**MINERALS PROGRAM INSPECTION REPORT**  
**PHONE: (303) 866-3567**

MINE NAME: Henderson Mine	MINE/PROSPECTING ID#: M-1977-342	MINERAL: Molybdenum	COUNTY: Clear Creek, Grand
INSPECTION TYPE: Monitoring	WEATHER: Clear	INSP. DATE: August 27, 2024	INSP. TIME: 09:00
OPERATOR: Climax Molybdenum Company	OPERATOR REPRESENTATIVE: Miguel Hamarat	TYPE OF OPERATION: 112d-3 - Designated Mining Operation	
REASON FOR INSPECTION: Normal I&E Program	BOND CALCULATION TYPE: None	BOND AMOUNT: \$143,264,468.00	
DATE OF COMPLAINT: NA	POST INSP. CONTACTS: None	JOINT INSP. AGENCY: None	
INSPECTOR(S): Nikie Gagnon	INSPECTOR'S SIGNATURE: 	SIGNATURE DATE: September 18, 2024

Photo 7: Looking south at the berm above the highwall on the north end of the gravel pit.

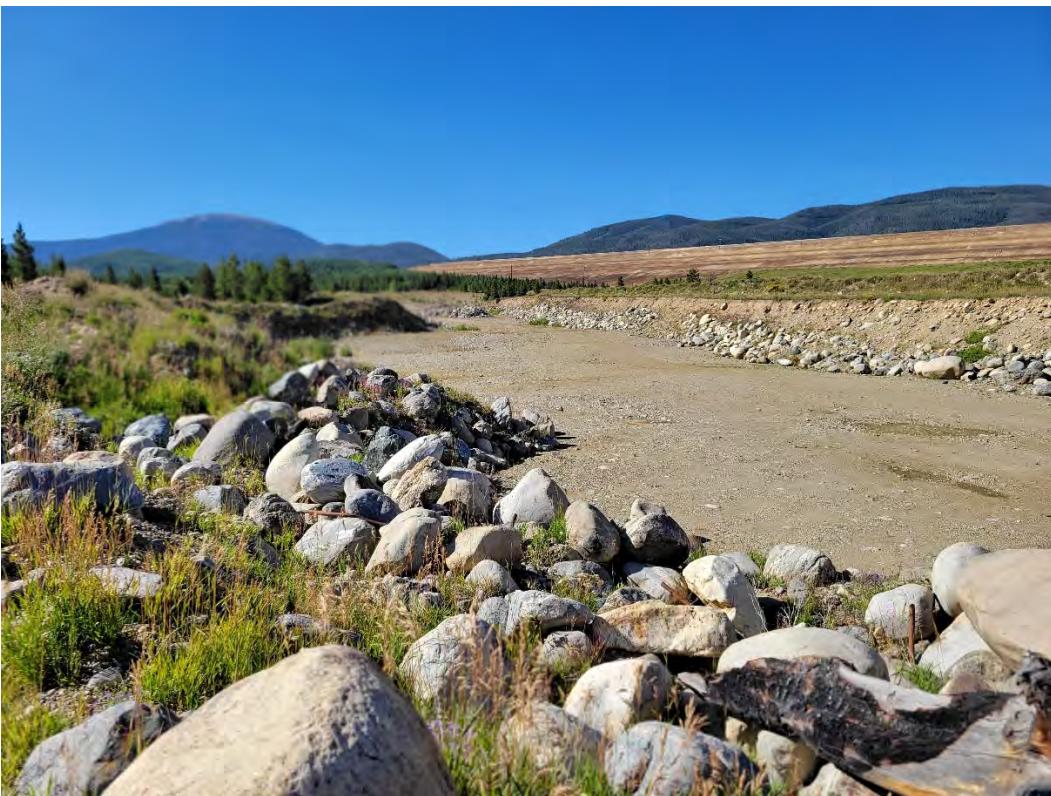
The gravel pit was originally developed in the 1970s for construction of the Henderson Mill. Over the years, the operation utilized the pit for sand and gravel for various projects at the site. Mr. Hamarat stated the last time material was excavated from the pit was 2012. The gravel pit is located along the eastern permit boundary and is split into two distinct areas. north and south. The south area, near the entrance, is currently utilized as a stockpile area. The mining pit is located on the north side. The pit floor is relatively flat and contains a few stockpiles of mined material. Two highwalls areas, each approximately 600 feet long, were observed along the east side of the pit. A small area of ponded stormwater was noted in front of one of the highwalls. The Operator stated they will regrade the pit floor to allow better drainage of stormwater. The reclamation plan calls for grading the slopes to 3H:1V , topsoiling and seeding. The Division observed a slope on the south end of the pit that has been graded to 3H:1V, but no other reclamation work has been completed to date. A vegetated berm of topsoil sits above the highwalls that will be utilized in reclamation.

Photo 24: Topsoil stockpile location depicted on the Reclamation Map in AM-8, near the Topsoil Shop.

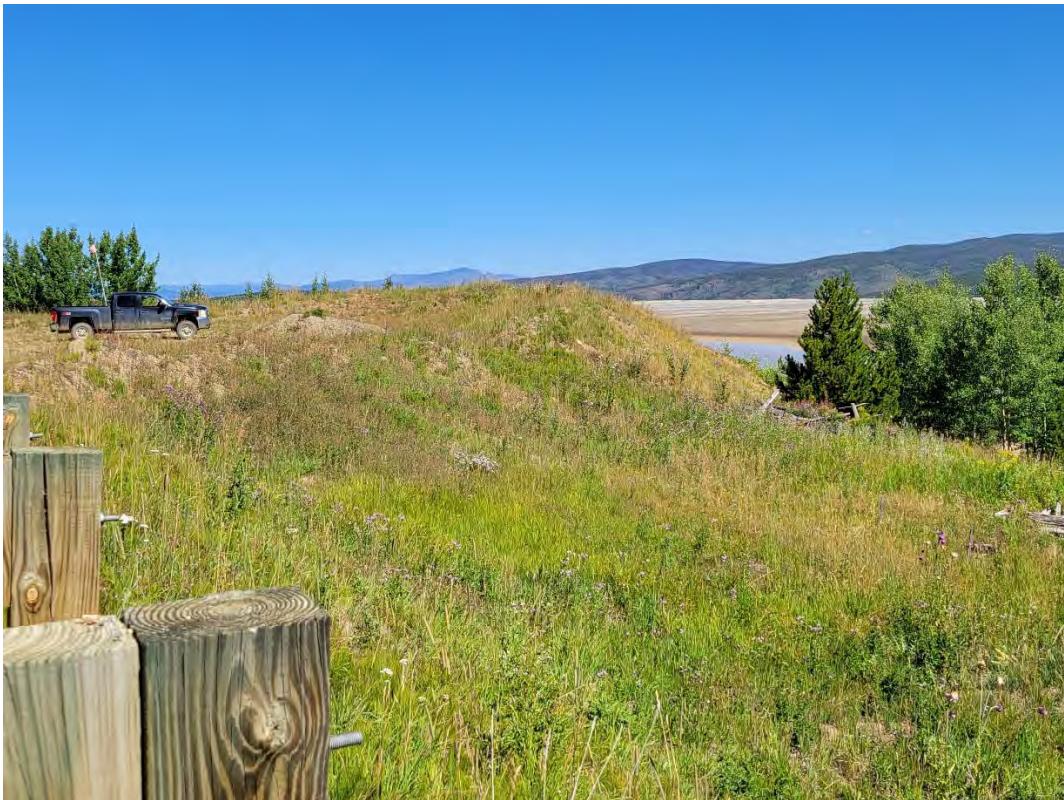
**Topsoil Shop Locations:** On the western side of the TSF in an area known as the Topsoil Shop, two small topsoil locations are depicted on the Reclamation Plan Map in AM-8. During this inspection, the Division observed a vegetated slope above the shop, but Mr. Hamarat was unsure if topsoil is stored in this location. The map in AM-6 shows approximately 100,000 CY of storage, however, in a follow-up email from Mr. Hamarat, he stated that these two locations contain an insignificant volume of topsoil.

**HENDERSON MILL**  
Reclamation Plan Map  
Exhibit FA to AM-08

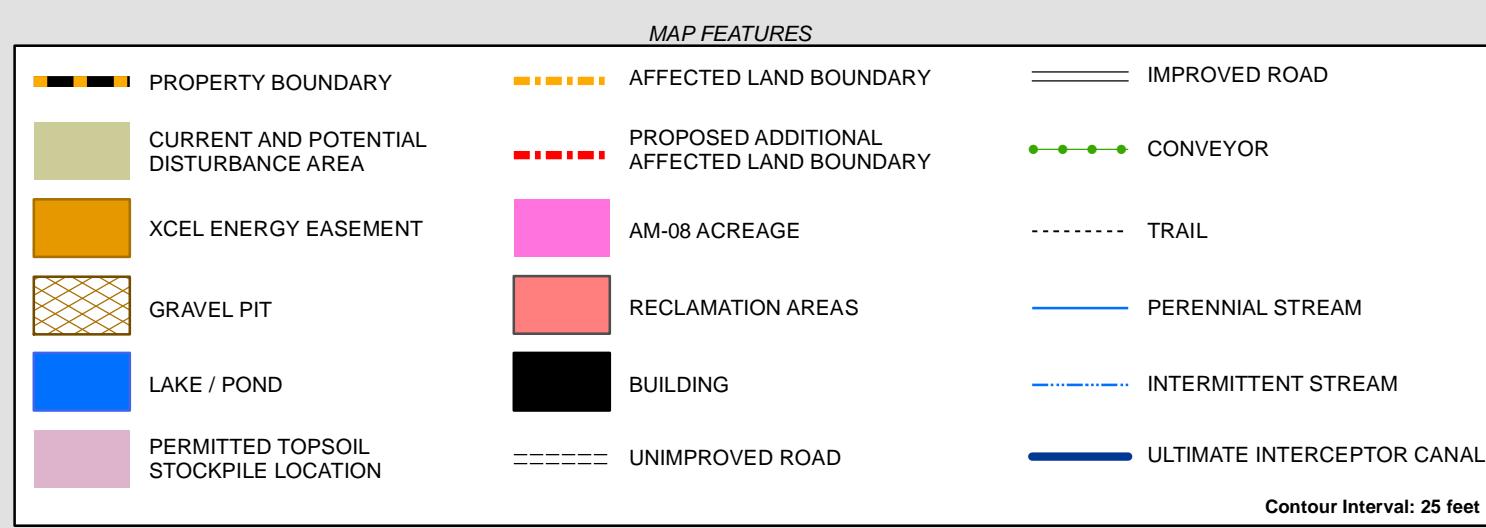
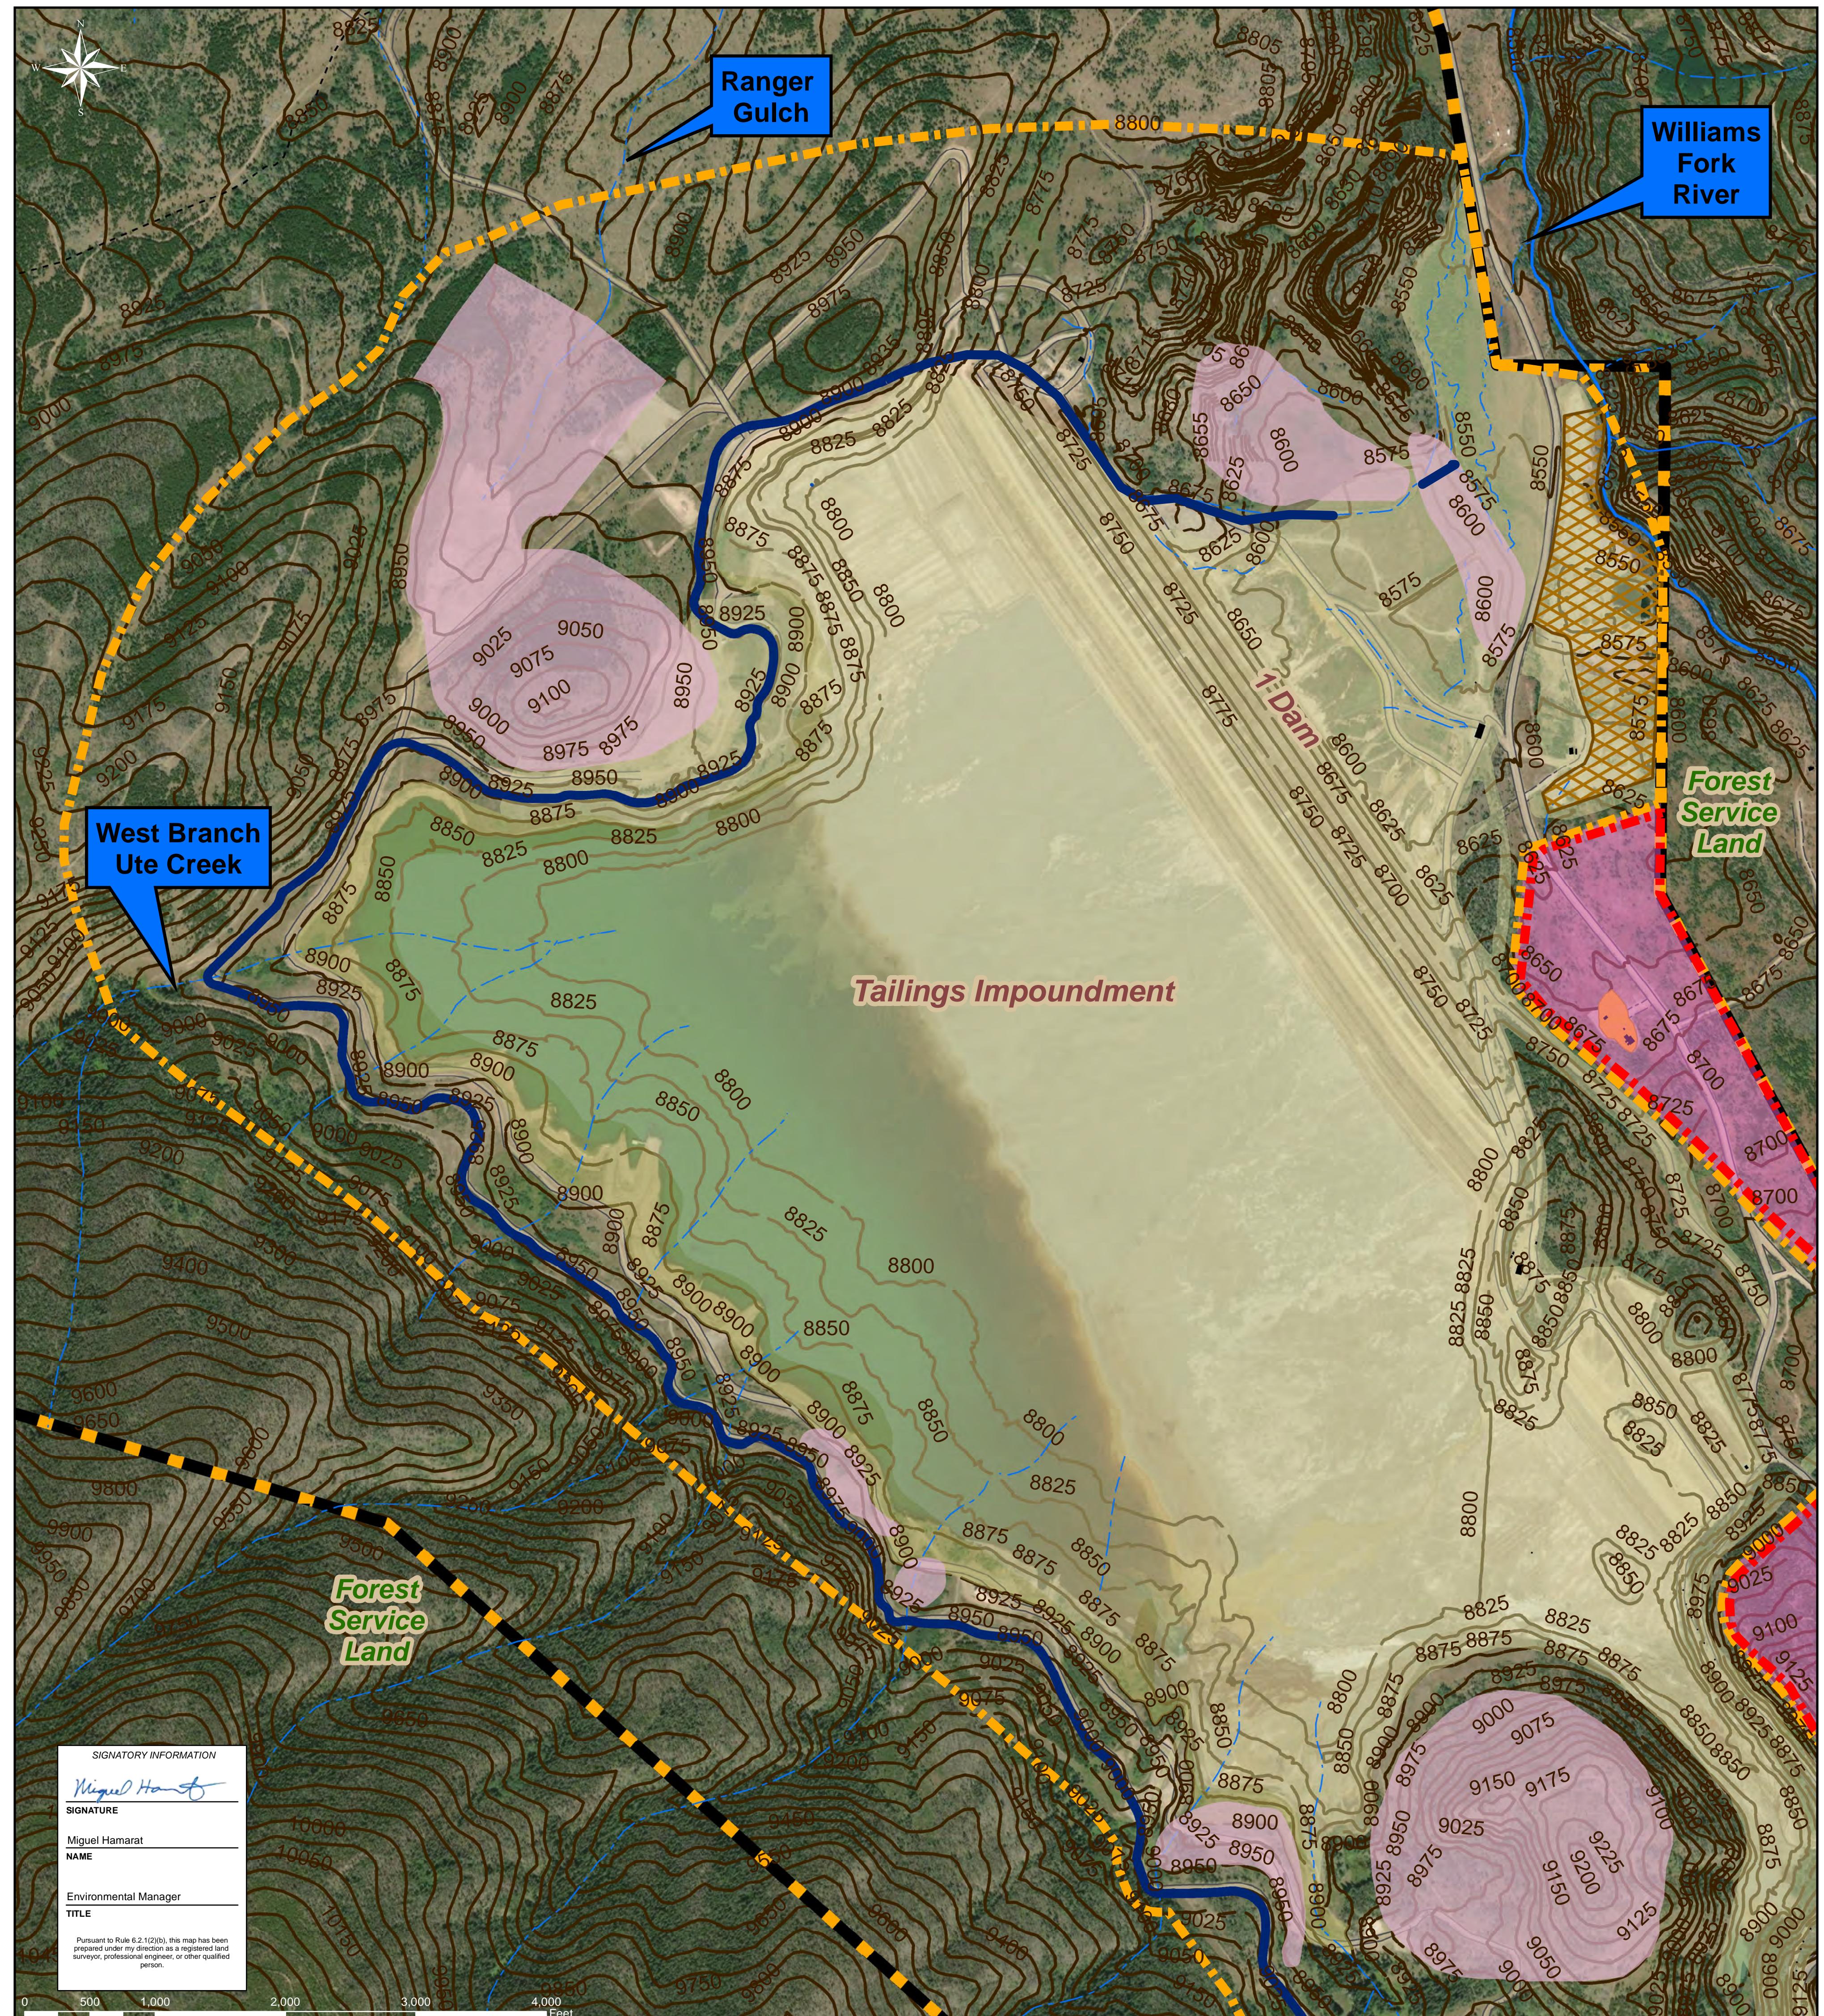
The Reclamation Plan Map in AM-8 depicts a large round topsoil location at the southern end of the TSF. Mr. Hamarat informed the Division that the location is not being utilized for topsoil storage.

*Based on a review of the permit file, and observations during this inspection, the Division requests that the Operator submit a Technical Revision to update the topsoil stockpile location map and provide an estimate of the volumes within each location.*
